State of Alaska
Department of Fish and Game
Public Review Nomination for Waters
Important to Anadromous Species

☐ Addition X Correction ☐ Deletion

Name of Waterbody (if known): 306-50-11600

Anadromous Waters Catalog Volume and Number SW III

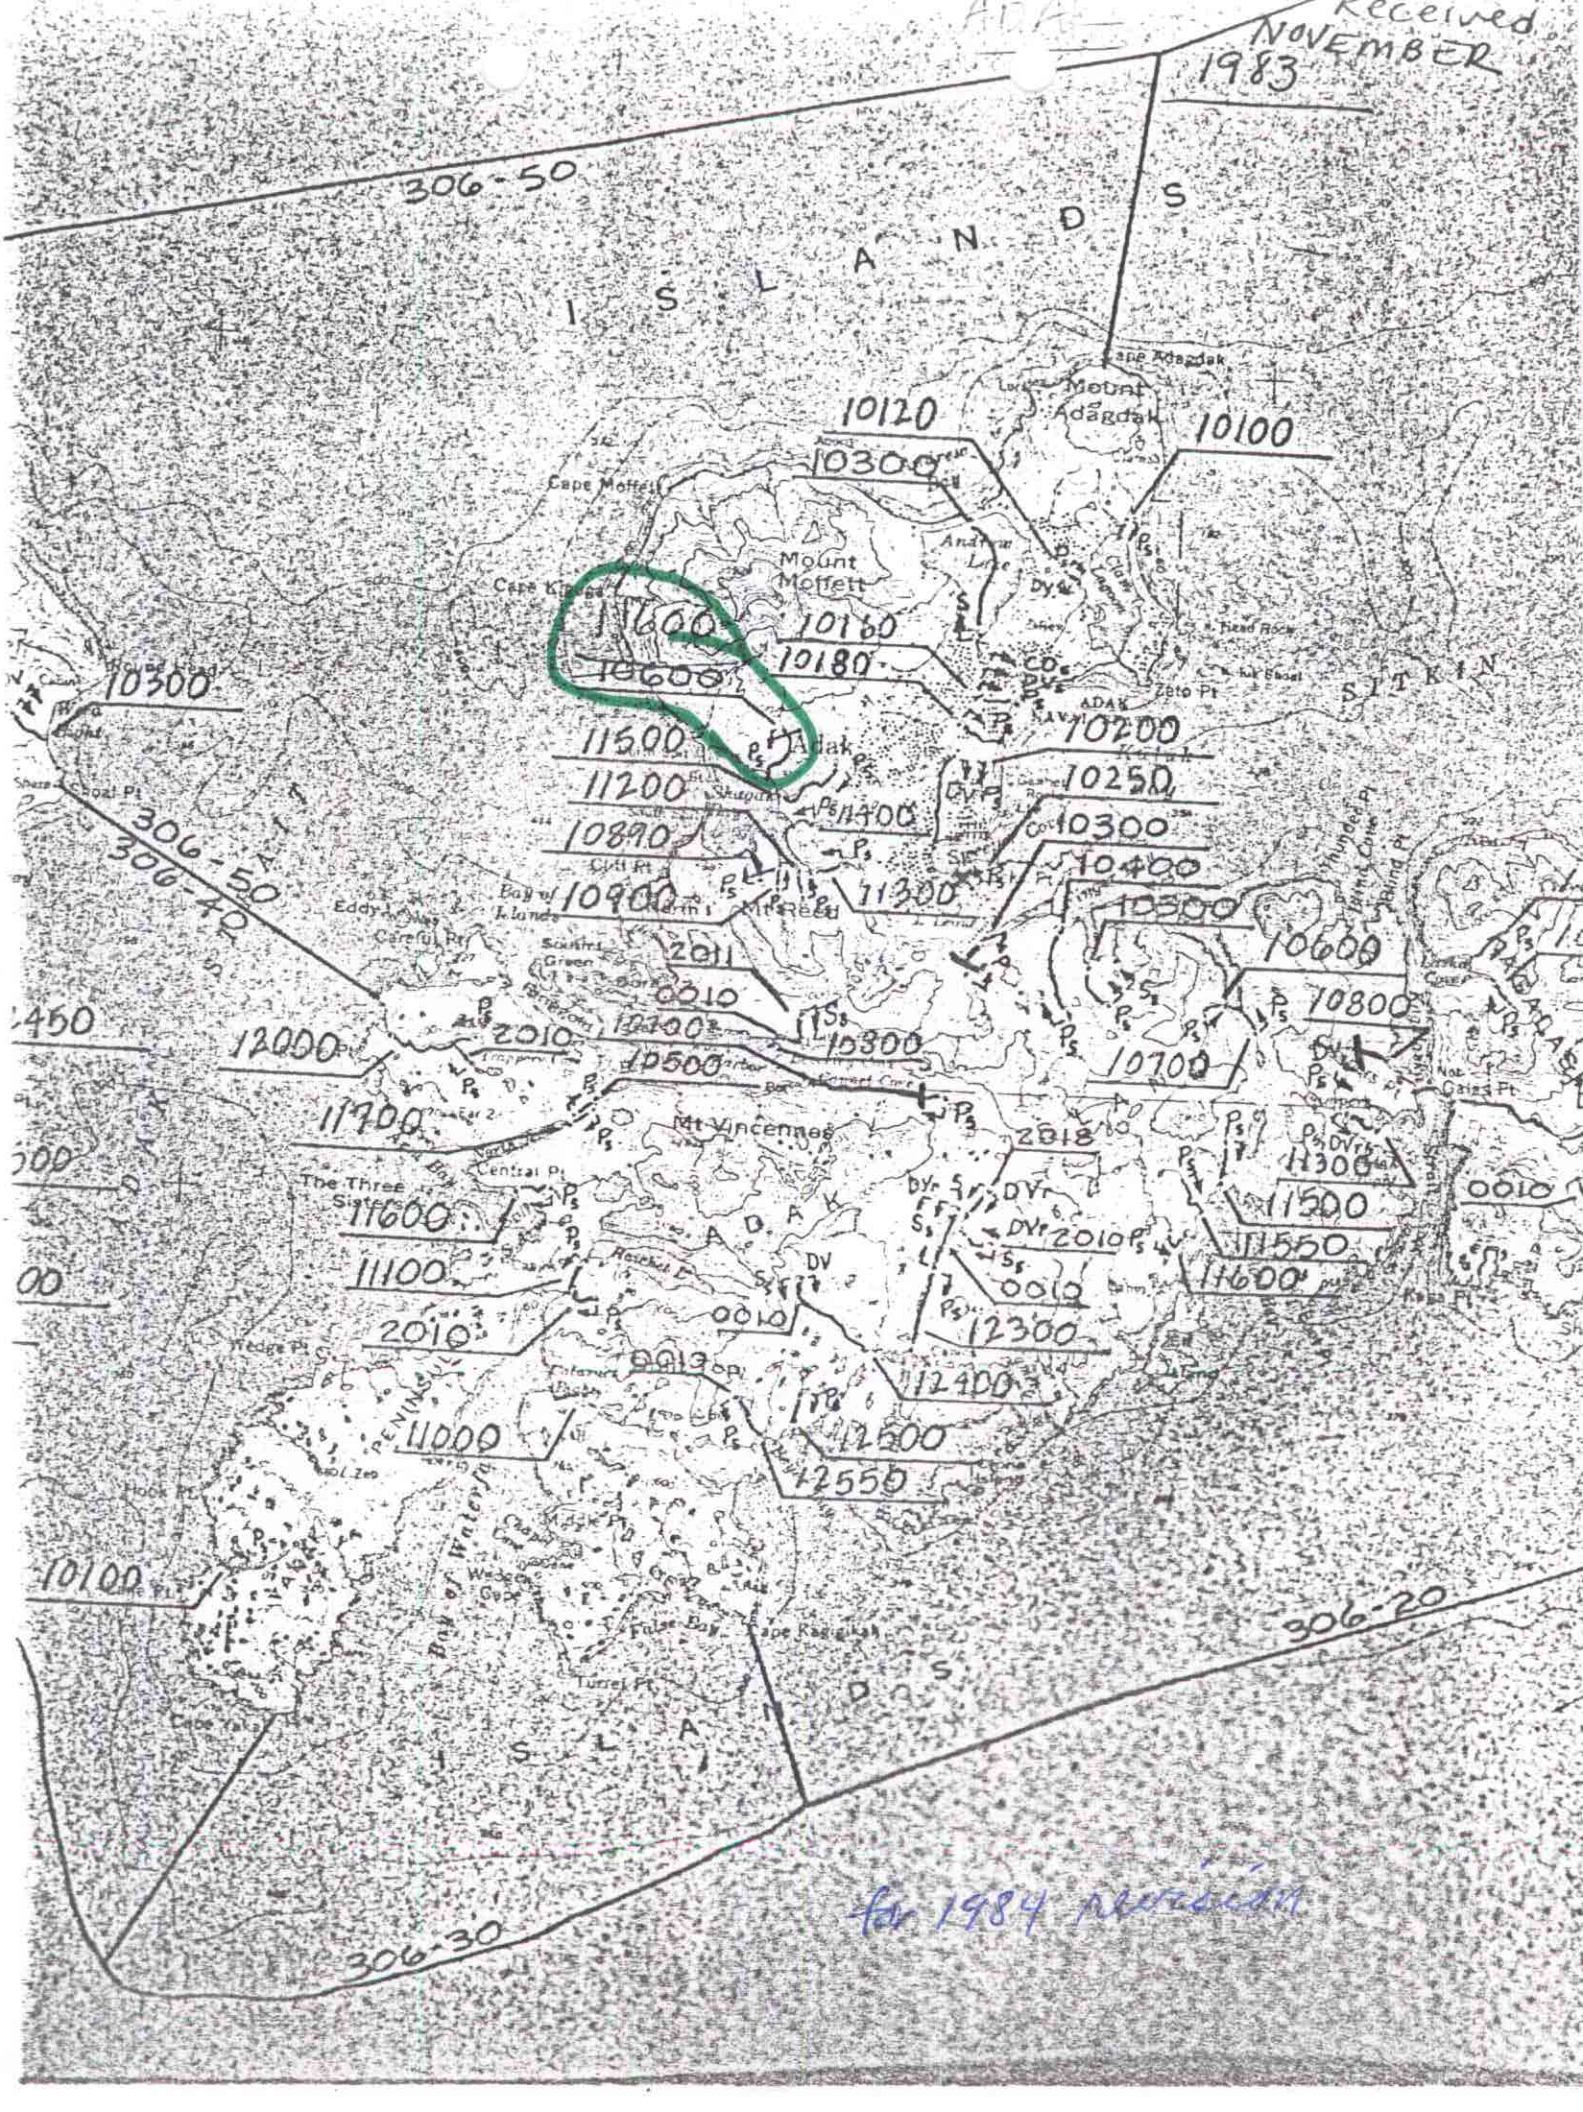
map was drafted too long. See attached map and memo from Pat Holmes. Correct upper point. Holmes had also requested that the stream be shortened in the 1983 revision (see '83 map)

Adak Island:

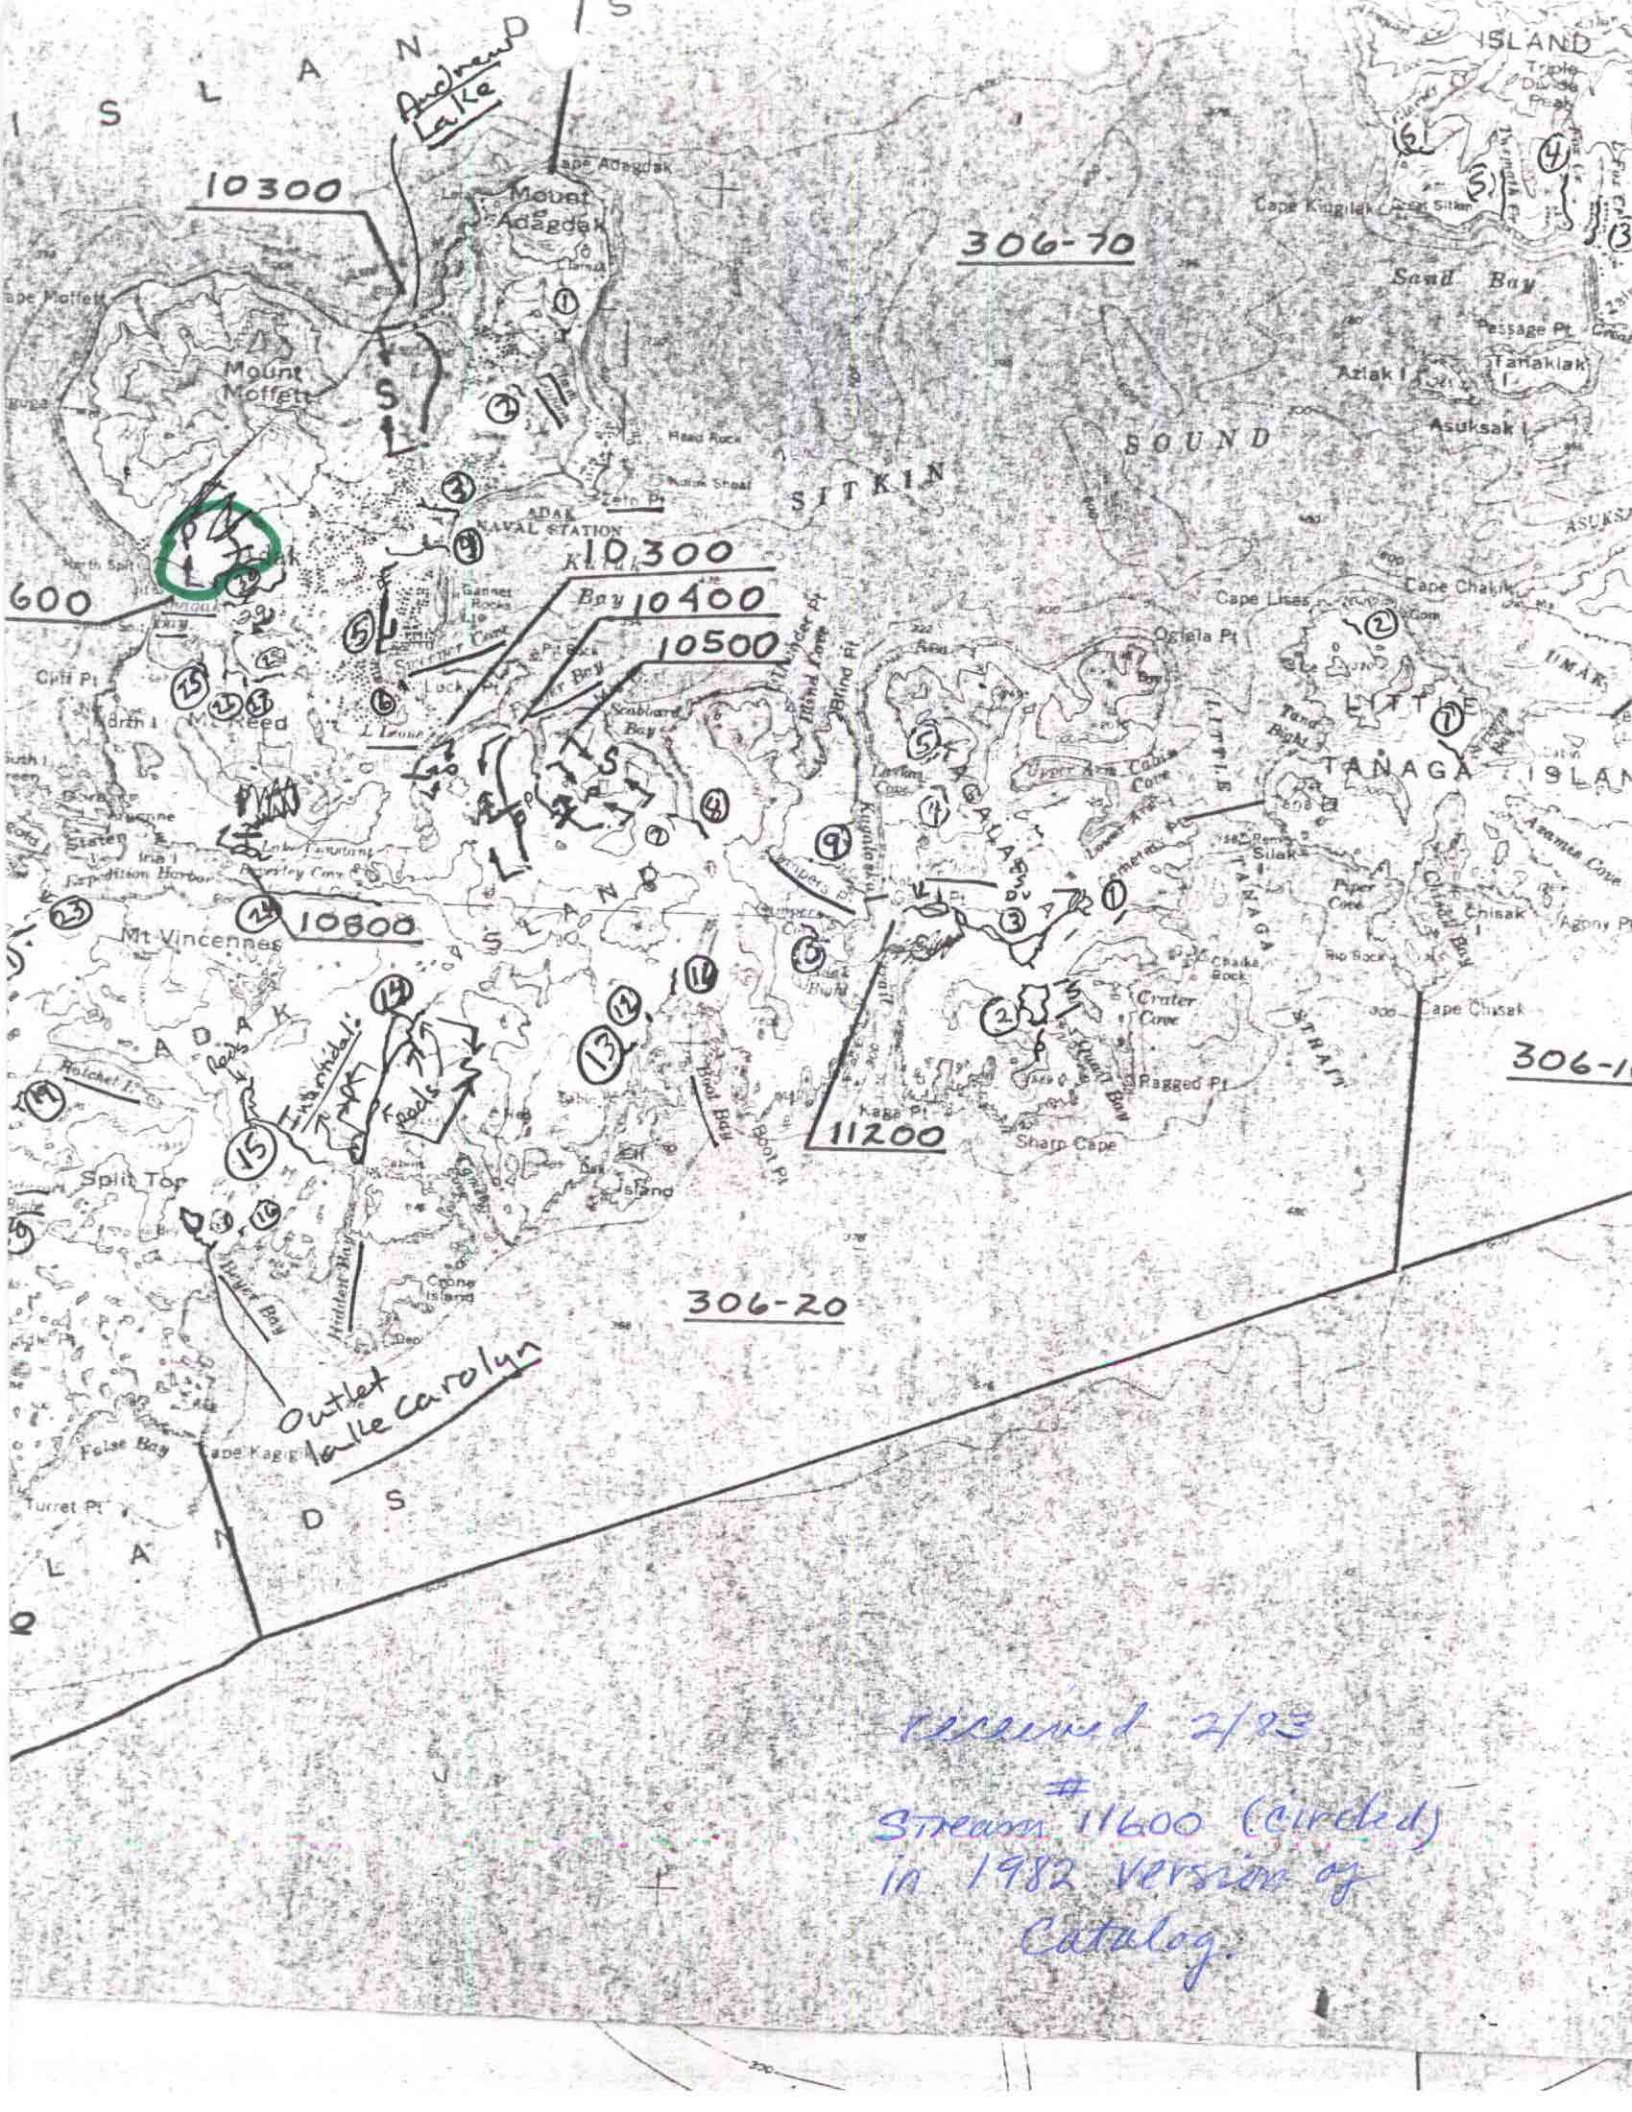
Your cartographer or possibly myself were a bit loose with the pen or outlining the length of a few streams. I have included a map with corrections outlined in red.
